PLANNING AND ZONING COMMISSION MEETING AGENDA

February 07, 2024 at 7:00 PM

Town Hall - 1941 E. Jeter Road, Bartonville, TX 76226

1. Discuss and make a recommendation regarding a Preliminary Plat for a 101.467-acre property situated in the Daniel Cook Survey, Abstract Number 230, and A.M. Feltus Survey, Abstract Number 1594, in the Town of Bartonville, Denton County, Texas. The property is located on the north side of E Jeter Road, approximately 2,185 feet east of the intersection of E Jeter Road and Country Court, in Bartonville, Texas. The applicant is Mycoskie & Associates, Inc., on behalf of Knight's Landing West. [Town of Bartonville PP-2023-004.]

Exhibit 1

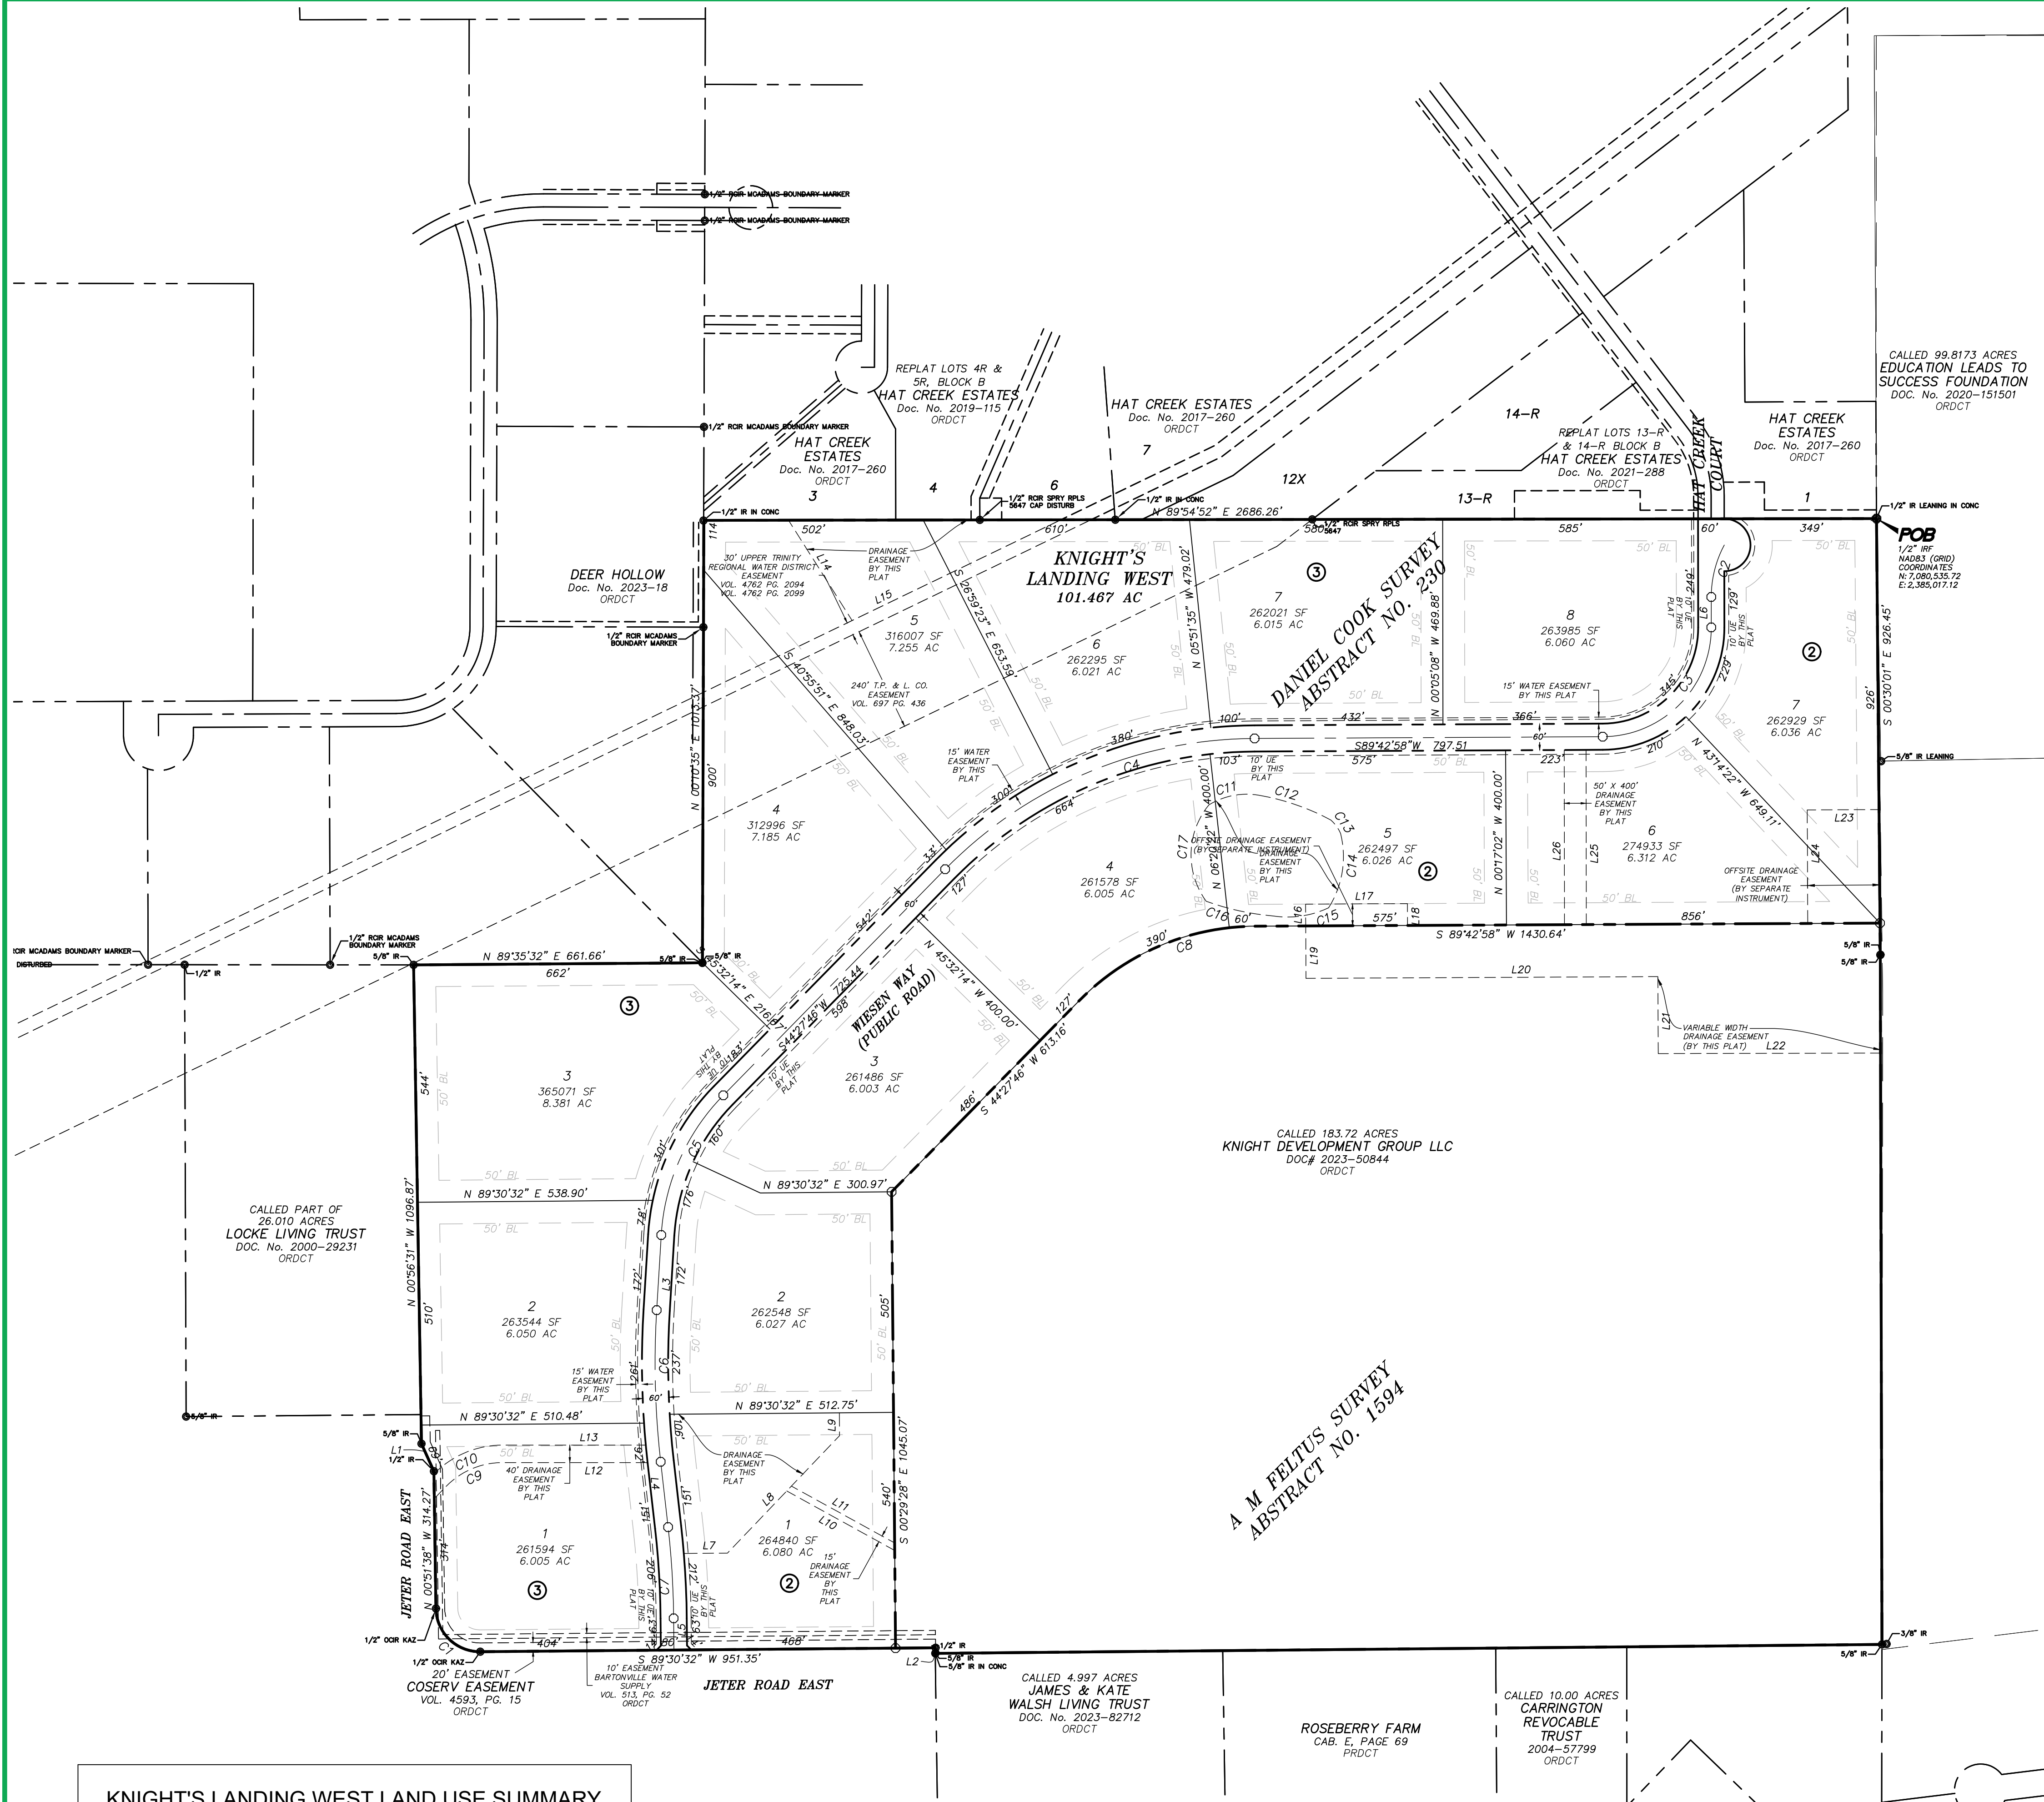
1. Prior to recordation of the final plat, the two “Offsite Drainage Easements” depicted on the preliminary plat shall be recorded as separate instruments. The recording number for the easements added to the plat prior to recording. Alternately, the easements can be established via the Knight’s Landing West plat by revising the label to read ‘by this plat.’ Be advised that the timing of the easement dedication is also a condition of approval for the Knight’s Crest plat (Town File No. PP-2023-003).

2. On the final plat, the drainage easement labels located in Block 2, Lot 3 shall be adjusted so they do not overlap.
3. Prior to recordation of the final plat, the plat and accompanying planning materials shall be reviewed and approved by the registered sanitarian for the Town of Bartonville, in accordance with Title 30, Texas Administrative Code, Chapter 285, Section 285.4(c).

7. On the final plat, the Notes on sheet 1 and General Notes on sheet 2 shall be consolidated onto sheet 2. Note 1 in each case shall be combined or corrected to reflect the correct references.

PRELIMINARY UTILITY PLAN
KNIGHTS FAMILY COMPOUND WEST
PHASE ONE
BARTONVILLE, TEXAS

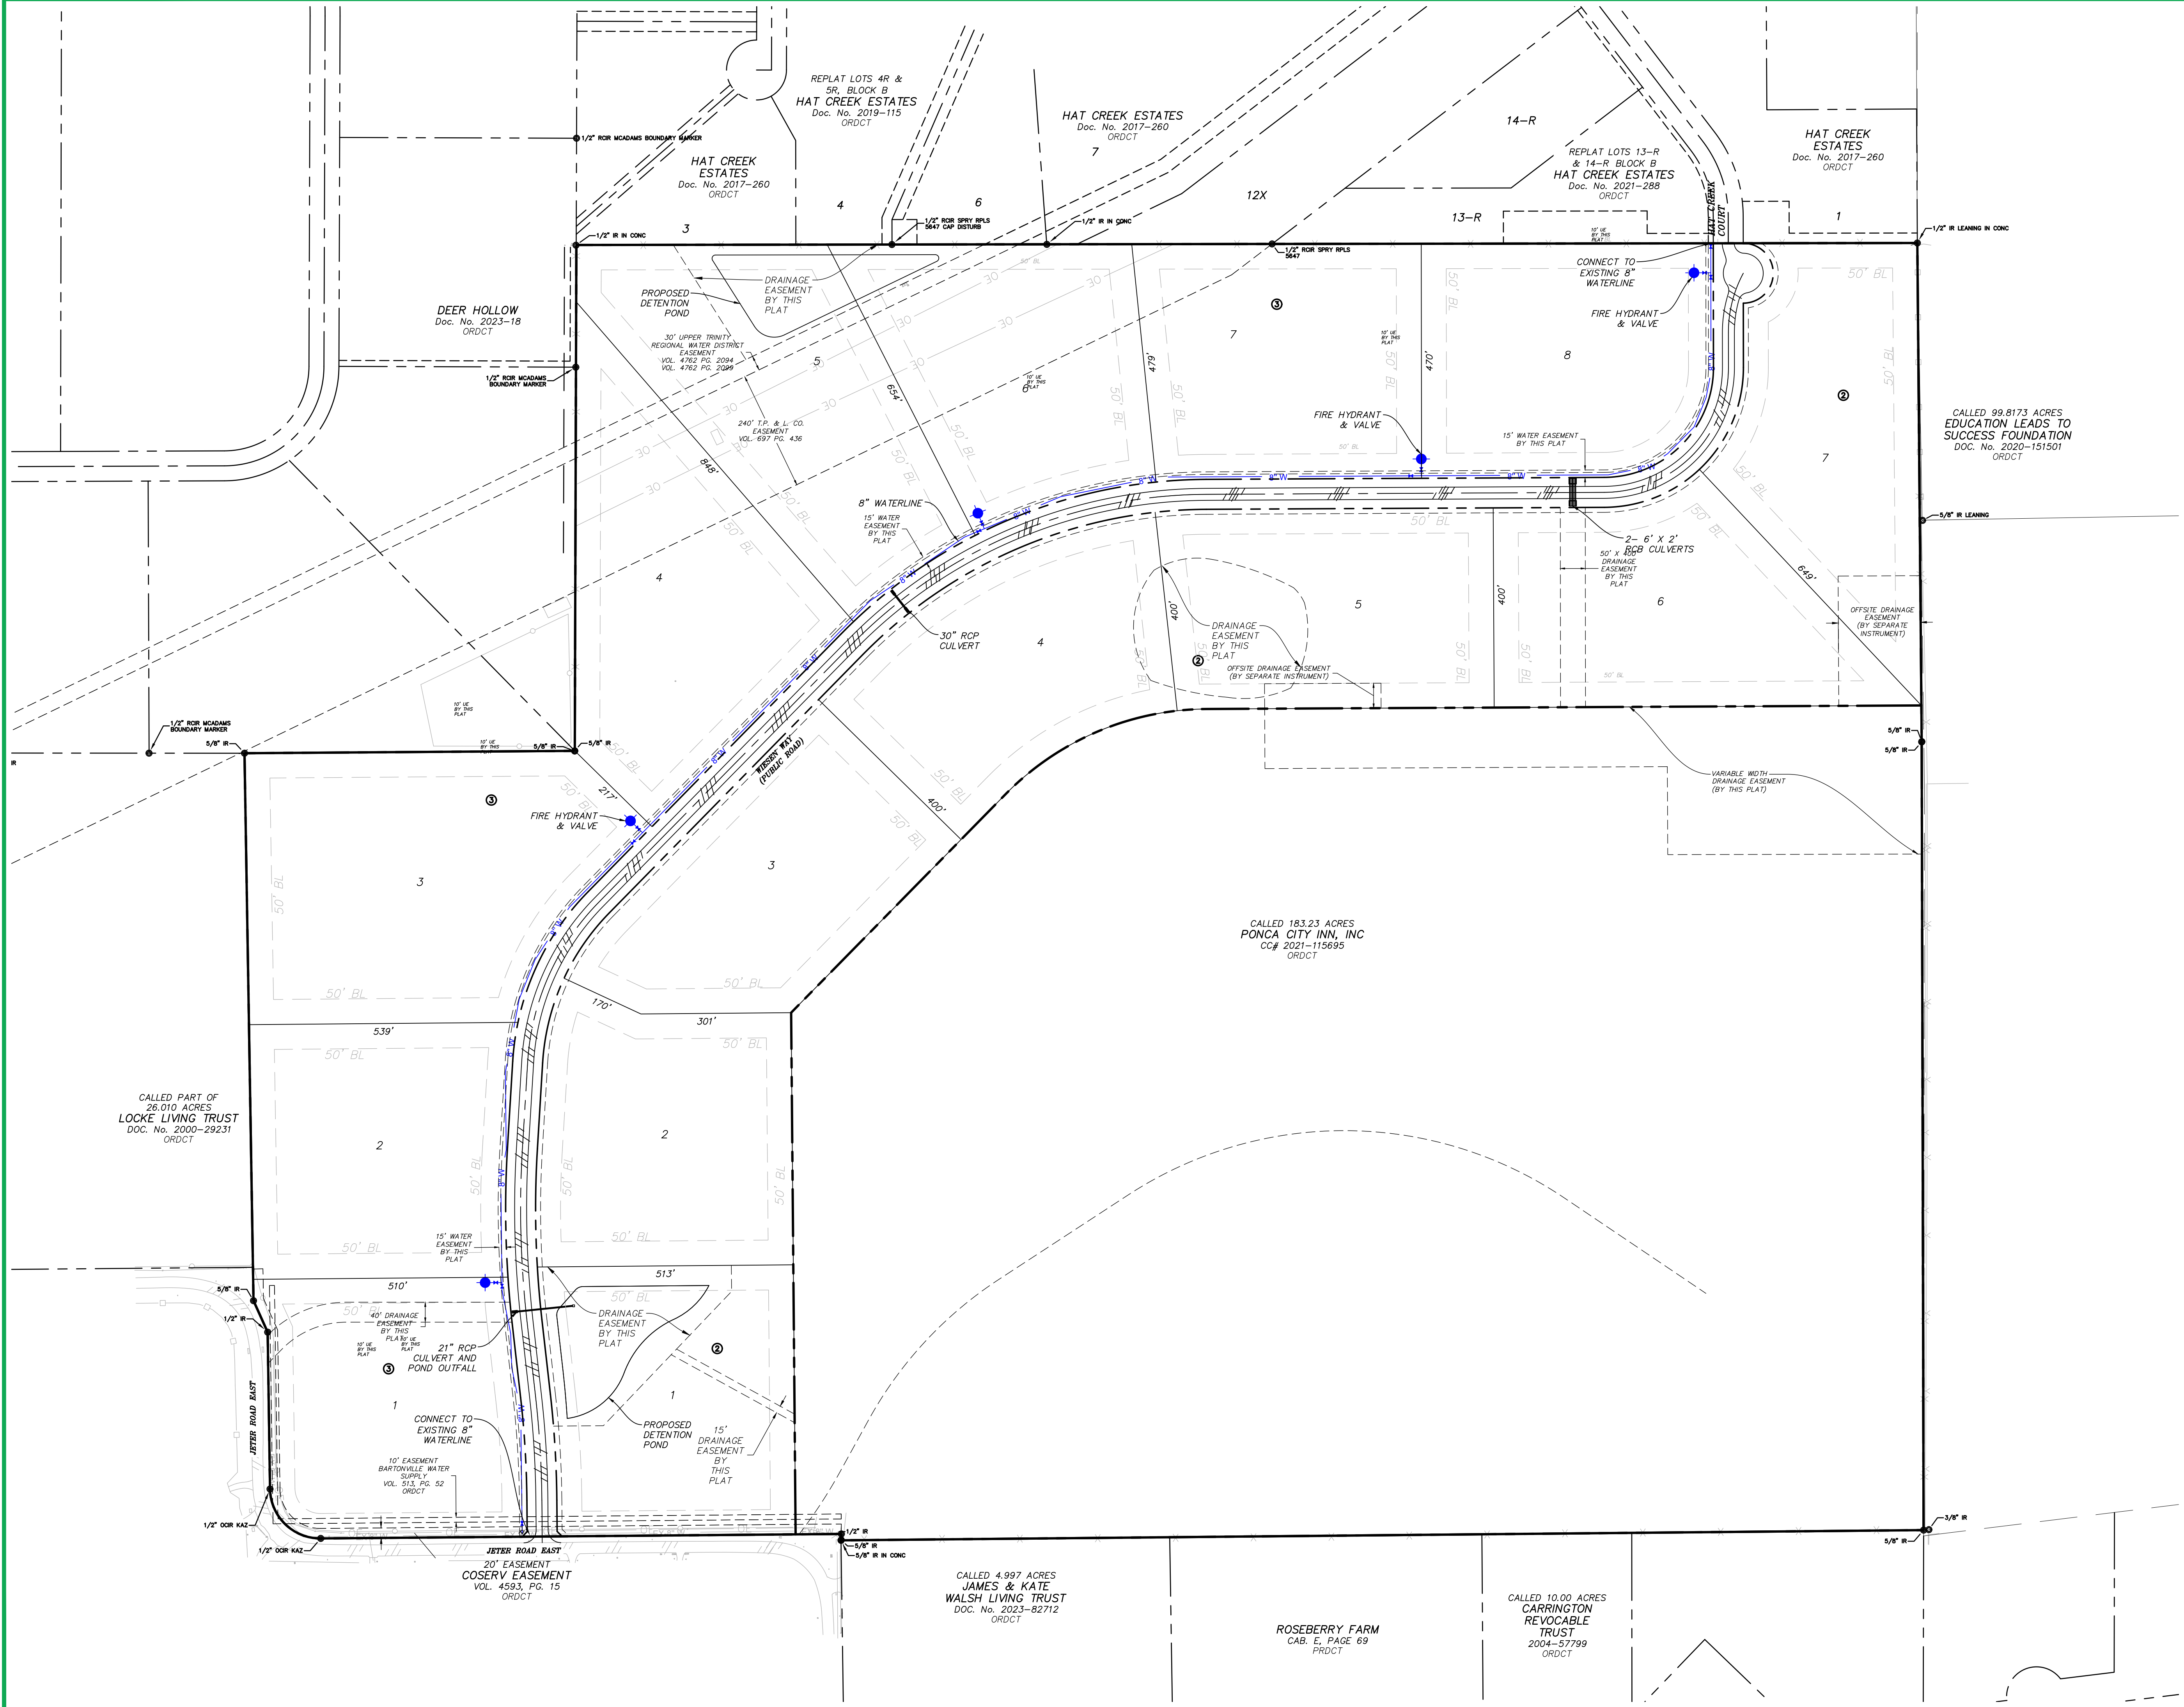
5. The engineering/construction plan set shall show fire hydrant spacing that meets the Denton County ESD No. 1 spacing standards.
6. Accompanying the final plat application shall be copies of letters from applicable local utility companies stating that each utility company has reviewed the preliminary plat and stating any requirements (including easements) they may have, in accordance with Bartonville Development Ordinance Section 2.5.h.
